IN THE MATTER OF:	)	
	)	
AMENDMENTS TO 35 ILL.ADM.CODE 225:	)	R09-10
CONTROL OF EMISSIONS FROM LARGE	)	(Rulemaking - Air)
COMBUSTION SOURCES (MERCURY	)	
MONITORING)	)

# TESTIMONY OF SCOTT MILLER ON BEHALF OF MIDWEST GENERATION

# REQUEST TO REPLACE PROPOSED REGULATORY LANGUAGE CONTAINED IN THE TESTIMONY OF SCOTT MILLER ON BEHALF OF MIDWEST GENERATION

Figure 8.10. In-Flight Mercury Removal Results of Full Scale Field Tests of Halogenated PAC Sorbent Injection on Low-Rank Coals (*Durham 2005, Staudt 2005, Nelson 2005*)

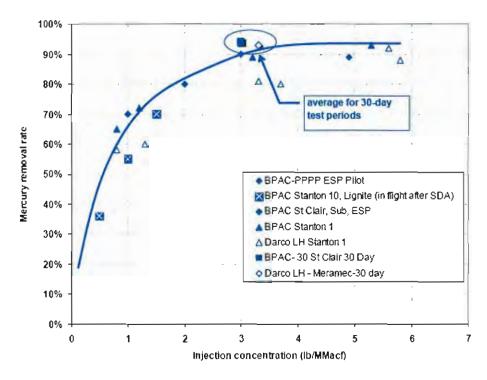
When IEPA determined that 5 lbs/macf was a conservative sorbent injection rate to ensure maximum mercury removal for units gaining temporary relief from the mercury standards in the original mercury rulemaking, it appears that IEPA never anticipated that sorbent injection would occur upstream of the air heater. Section 8.4 of the Technical Support Document ("TSD"), dated March 16, 2006, prepared by Dr. Staudt for the original mercury rulemaking describes mercury-specific controls. In particular, Figure 8.10 shows the mercury removal test results of halogenated powdered activated carbon ("PAC") on low rank coals:

Technical Support Document at 127, R06-25 (March 14, 2006). This illustrates that the data used to develop the Rule consisted of testing at the following units:

Although the TSD does not specifically describe the injection location in each of these tests other than that they are upstream of the ESP/baghouse, the reports of each test make it clear that the injection points were downstream of the air heaters. From this information, we can tell that the 5 lbs/macf injection rate was based on the flue gas flow rate as measured downstream of the air heater where the flue gas temperatures are much lower than the temperatures upstream of the air heater.
